SUBJECT : HASRPER CO., LTD.
FCC ID: O5XHP-420B
FCC Part 15 Subpart B Certification

FCC ID : O5XHP-420B
Model : HP-4200B

•ITEM of ADDITION

Alternate Tuner

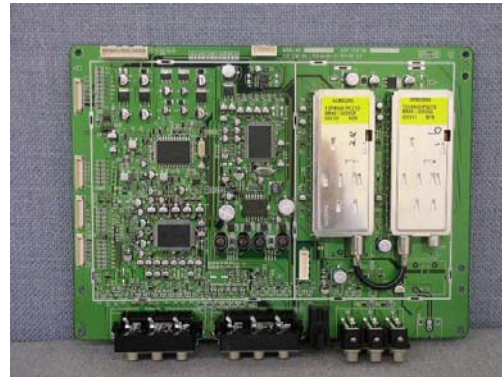
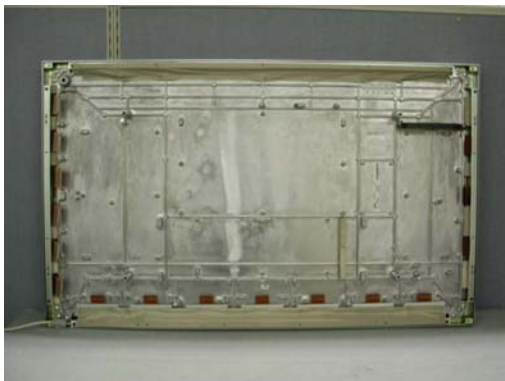
1. Change the tuner

Before : PIT-5NF05B S P3115S (PARTSNIC)

New : TCLN9081PC (SAMSUNG)

Alternate Panel

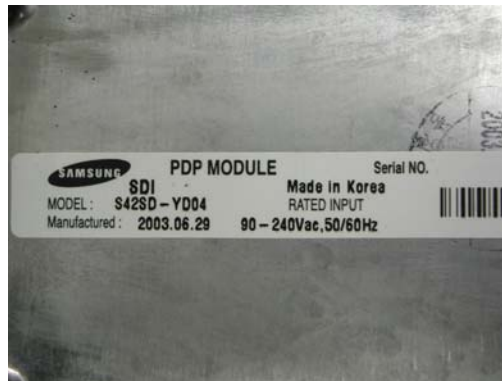
2. Change the panel

Before : S42SD-YD05 (SAMSUNG)

New : S42SD-YD04 (SAMSUNG)

•Solution for EMI

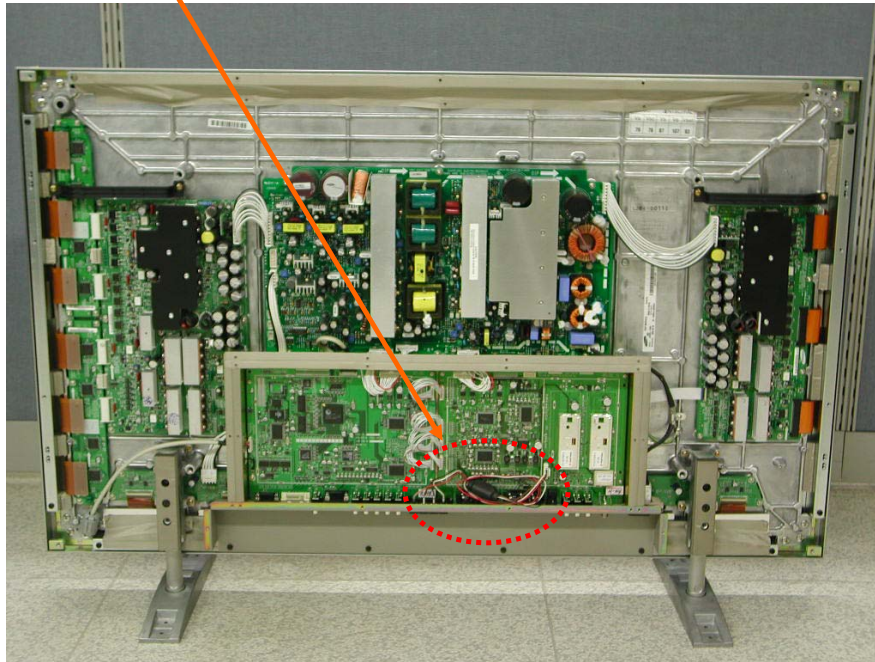
1. Apply a ferrite Core to the Main Board

2. Attach a gasket on the panel
